**PLEASANT VALLEY RECREATION & PARK DISTRICT
1605 EAST BURNLEY STREET, CAMARILLO, CONFERENCE ROOM**

**LIAISON COMMITTEE
AGENDA**

Re: **Structural Seismic Evaluation Report**
LPA Project No. 19060.10

Senior and Community Recreation Facility

BRACING AT (E) WALL

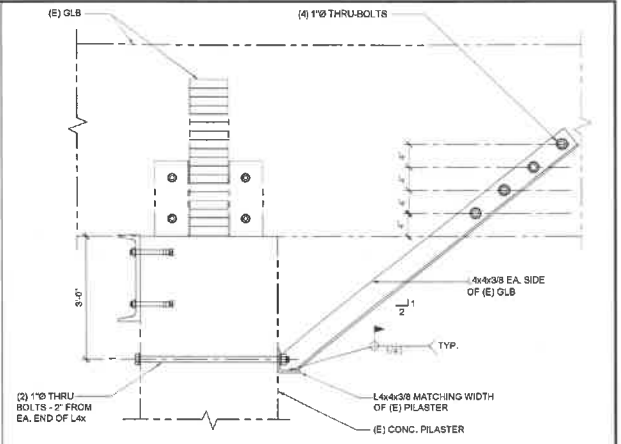
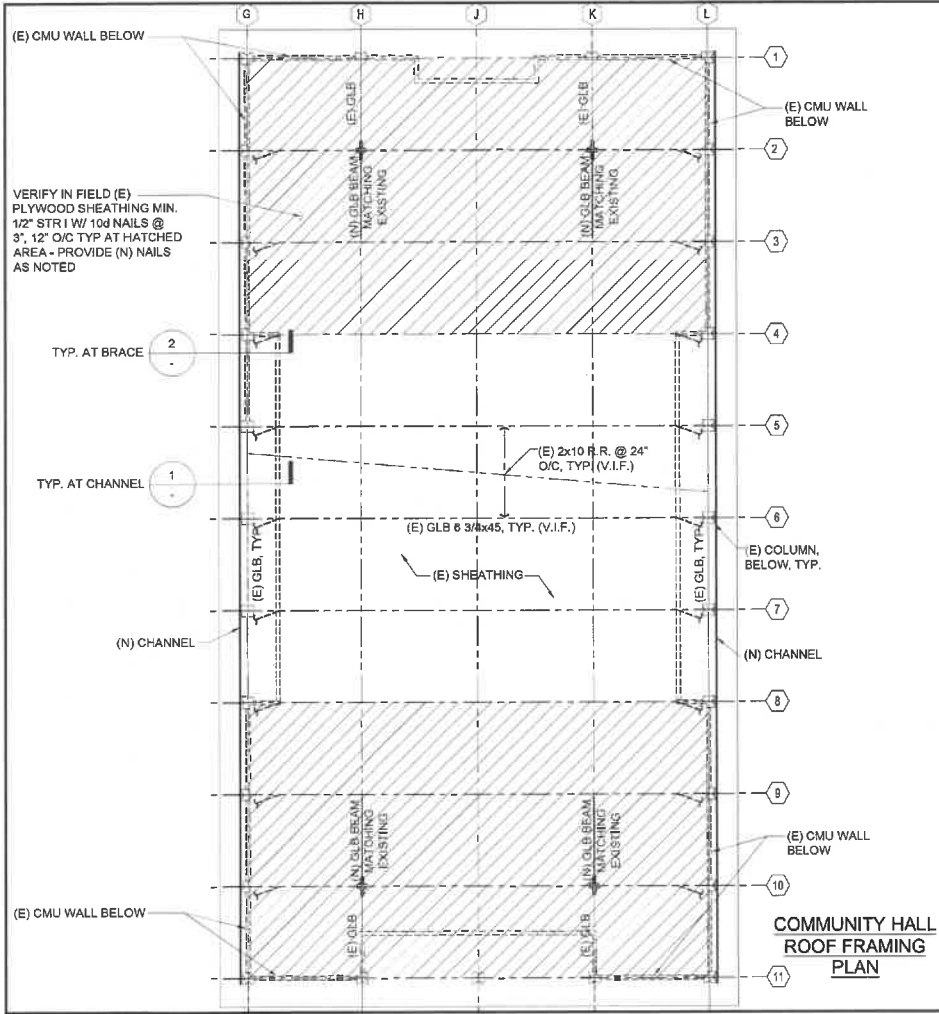
5. Due to lack of structural drawing, concrete columns may not have enough capacity to resist the out of plane loads. Recommend adding kickers to reduce the column unbraced height. See attached sketches. If larger capacity is required, carbon fiber reinforcement may be added to face of columns.
6. Glulam beam to concrete column connections may not have adequate capacity to transfer in plane shear nor anchor out of plane loads. Same recommendation as item 5 above.
7. Termite damage appears at a lot of the exposed end of glulam girders. Recommend conducting termite inspection by termite specialist and repair all damaged wood elements. Also recommend adding steel sheet metal caps at end of glulam.

CHANNEL TO (E) WALL

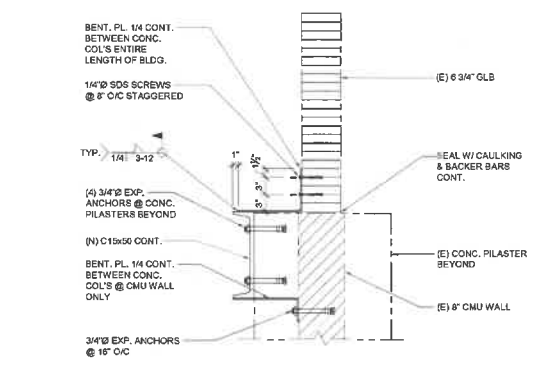
8. There are enough shear walls to resist in-plane seismic load for all 3 buildings.
9. For the older activity buildings, glulam beams connection may not have adequate capacity to transfer in-plane shear forces as well as out-of-plane anchorage forces to the concrete masonry wall below. Recommend adding 2 shear transfer steel plates connecting glulam beam to masonry wall between adjacent pilasters. Alternately, provide exploration destructive or non-destructive to determine existing connection assembly to justify adequacy.

Auditorium (continued)

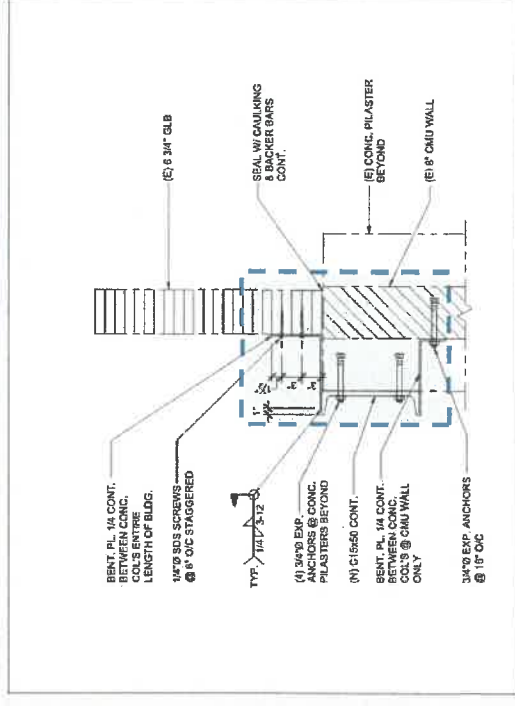
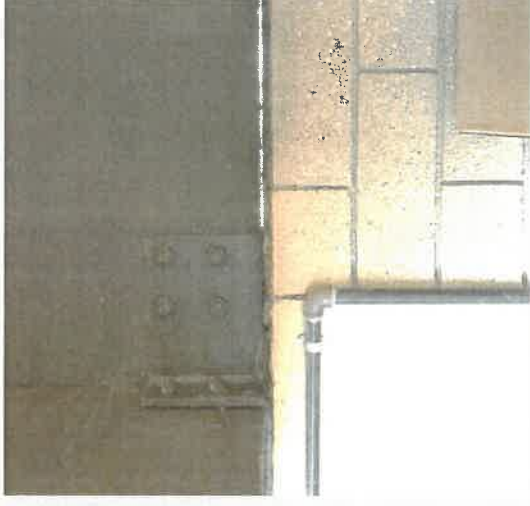
3. Lack of seismic transfer points to CMU
 - Continuous connection recommended
4. Further analysis required to determine CMU infill wall of plane resistance adequacy
5. Columns may require additional bracing
 - Kickers to reduce unbraced height
 - Carbon fiber reinforcement
6. Glulam may require additional bracing
7. Termite damage at glulam
 - Recommend termite inspection & repair
 - Recommend adding metal caps at glulam ends
